CITY OF SAN ANTONIO

Re: **Anaqua Springs MDP**

MDP # 797-A

ANAQUA SPRINGS RANCH, P.U.D. MASTER DEVELOPMENT PLAN

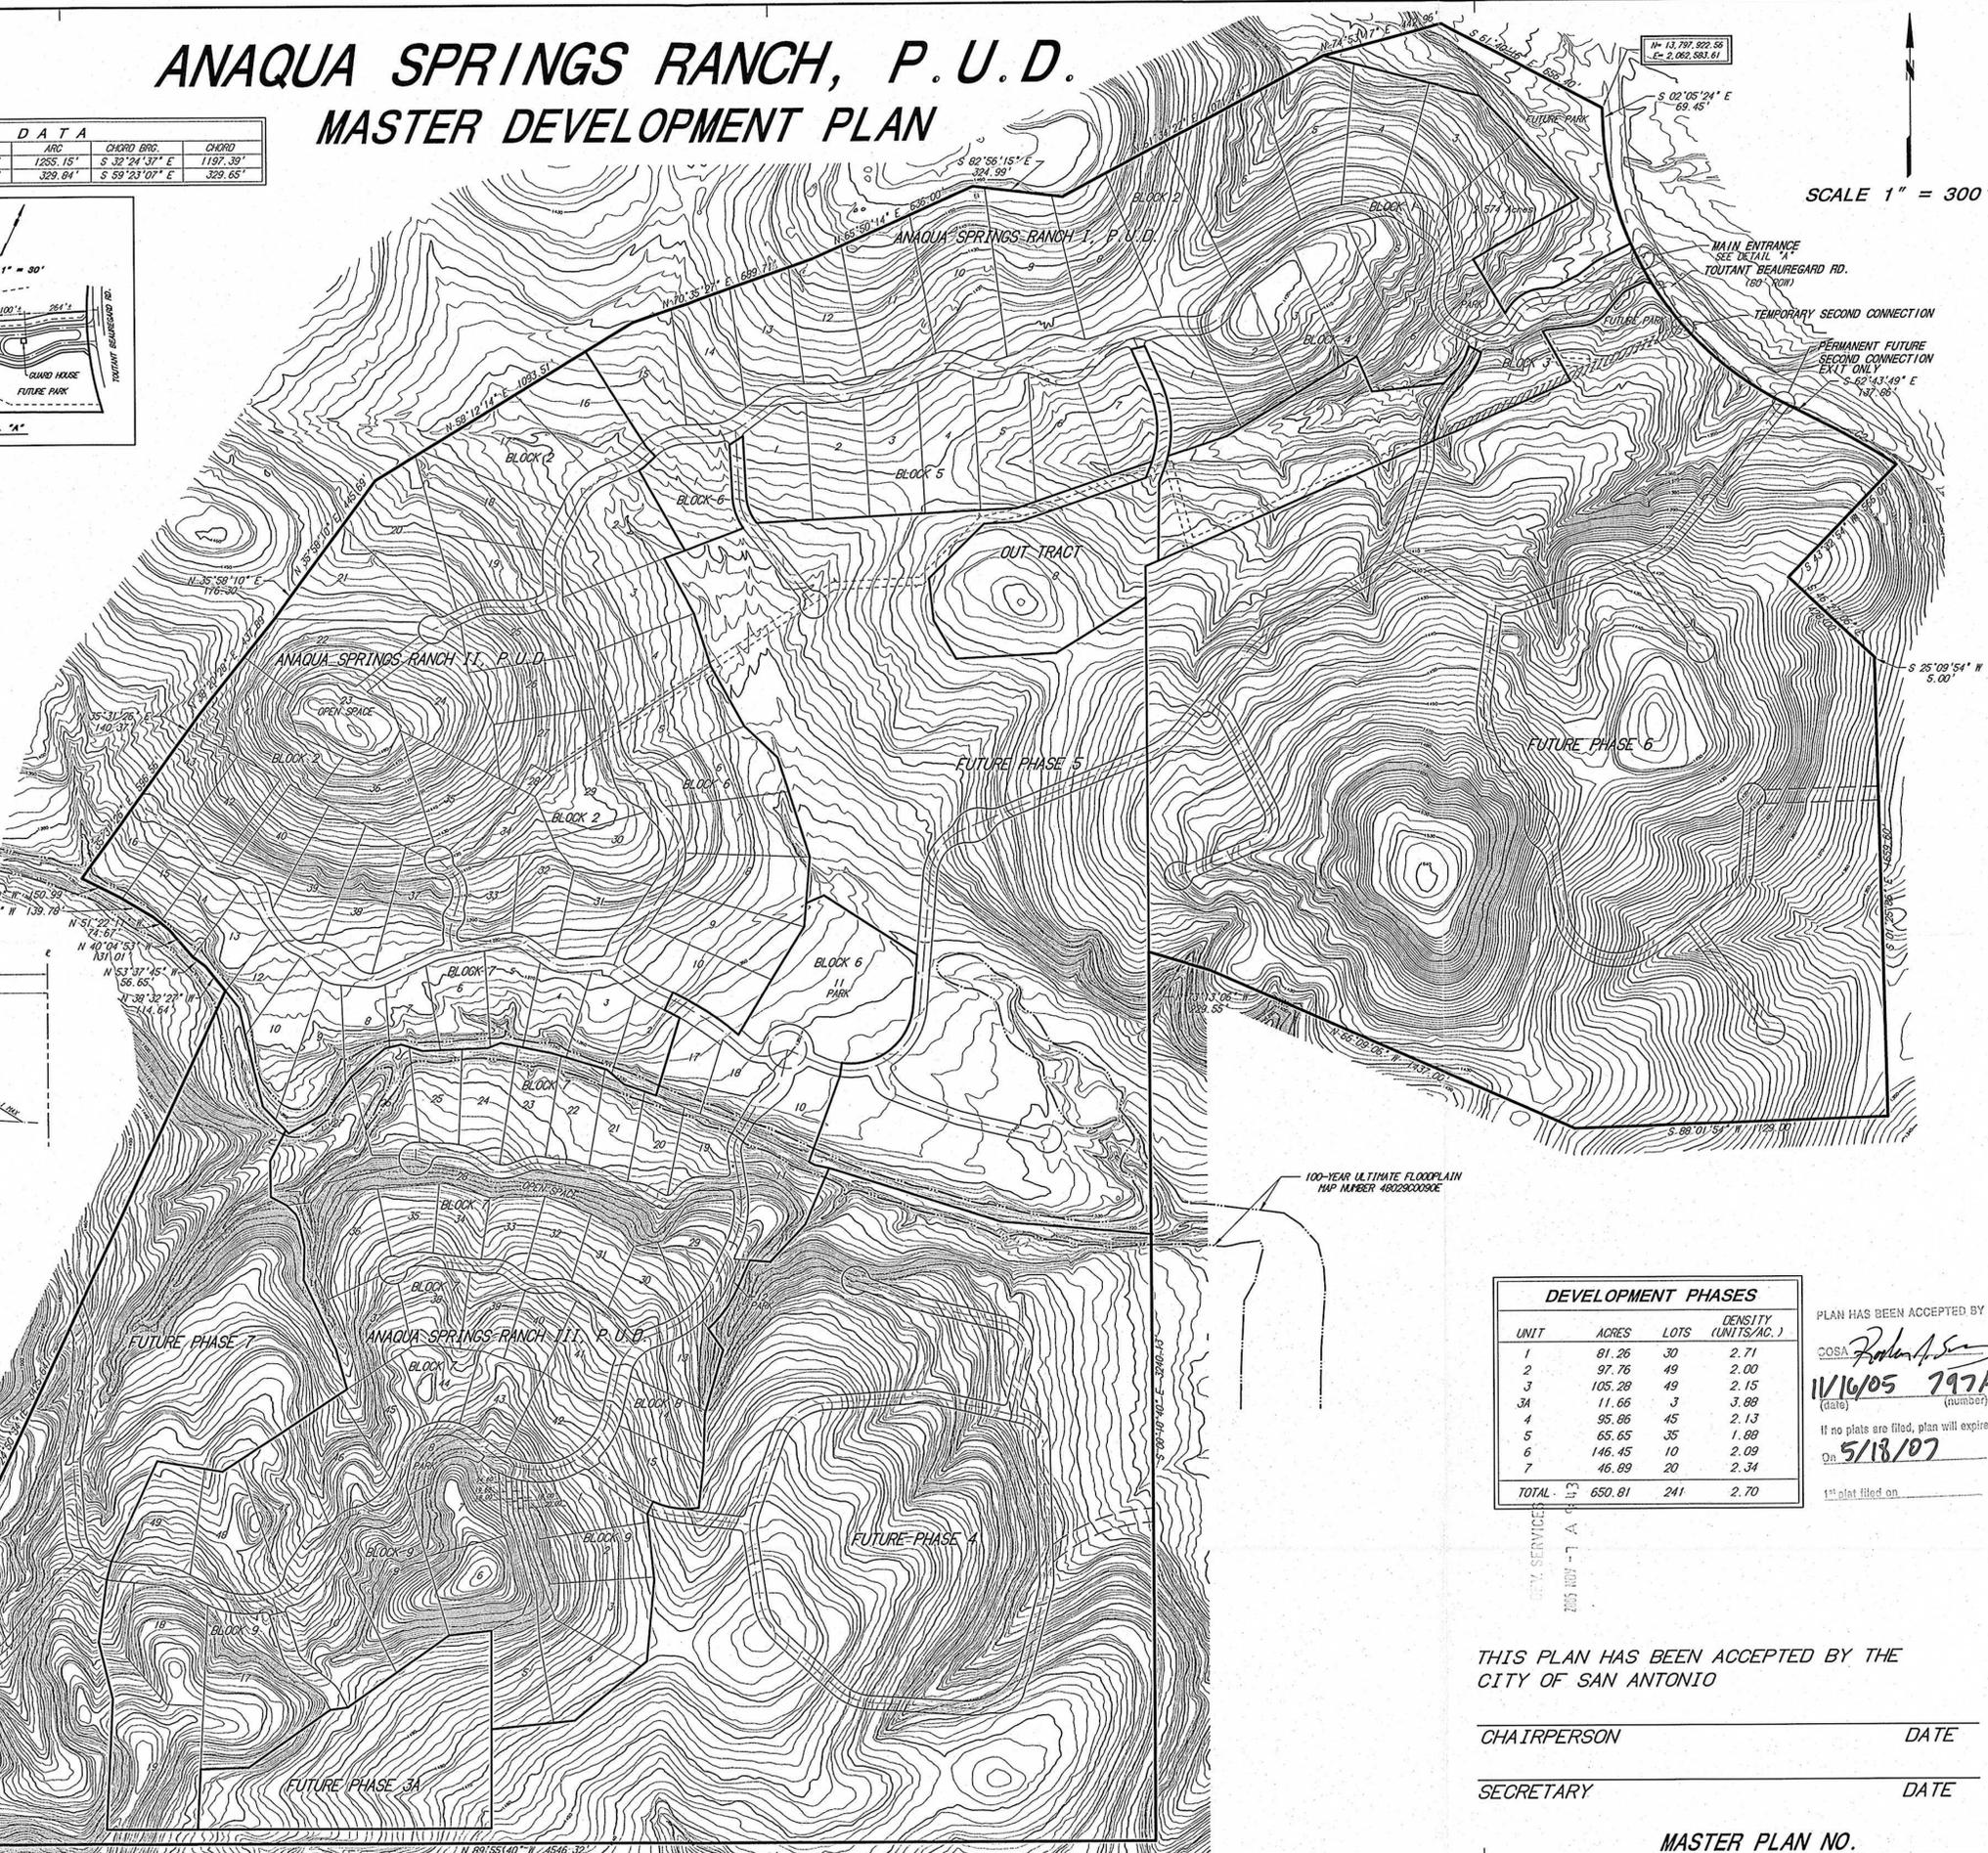
- In consideration of public safety and convenience, excessive grades by reason of topography should be avoided in street layouts and arrangements.
- Any access and R.O.W. issues along state facilities will need to be resolved with the **Texas Department of Transportation (TXDOT)**. For information about these requirements you can contact TXDOT at 615-5814.

- MDP recommends approval with the condition that two of the projected roadways within the PUD associated with this MDP shall be built at the time of the platting of those phases. These projections are located at the south and southeast edges of the MDP Plan and feed into Phase 4 and 3a.

Plat Certification will require compliance with Aquifer Protection Ordinance 81491. This evaluation will require the following:

- 100 Year Flood Plain and buffering to be shown (if applicable)
- Sensitive Recharge Features and buffering to be shown (if applicable)
- Category Letter of all Site Specific Plats (Category 2 and 3 require Aquifer Protection Plan)
